Access Compliance Report Public Rights-of-Way (Curb Ramps)

Main Street: CHIQUITA_CANYON_DR		Cross Street: FAUNA_DR		Location:	S
---------------------------------	--	------------------------	--	-----------	---

ADA ID: RPRK211124125053	Ramp Type: Type 1 - Perpendicular	Initial Pass/Fail: Pass	Overall Compliance: No	Severity Score:	2
--------------------------	-----------------------------------	-------------------------	------------------------	-----------------	---

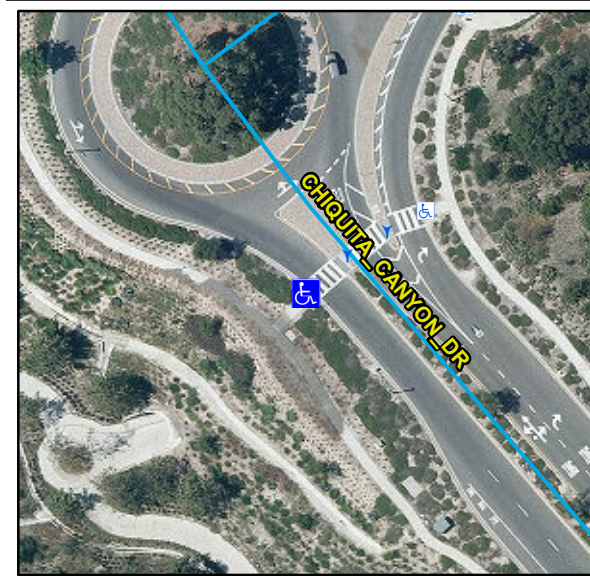
Yes	Ramp Inside Crosswalk 1	Yes	Yes	Ramp Inside Crosswalk 2	N/A
	Crossing 1 Slope (%)	5.3		Crossing 2 Slope (%)	N/A
	Crossing 1 Cross Slope (%)	0.1		Crossing 2 Cross Slope (%)	N/A
Yes	Gutter Ponding	No	No	Curb Slope	7.8
Yes	Gutter Lip Height (in)	0		Road Run Slope (%)	N/A
Yes	Gutter Run Slope (%)	4.2		Road Cross Slope (%)	N/A
Yes	Gutter Cross Slope (%)	0			
Yes	Overall Surface Condition: Acceptable		Yes	Perp Joint Present	Yes
	Cross Gutter Present?	No		Spandrel Present?	No
	Replace Cross Gutter?	N/A		Replace Spandrel?	N/A

Remove & Replace Curb Slope.

R304.2.2, STD 1115
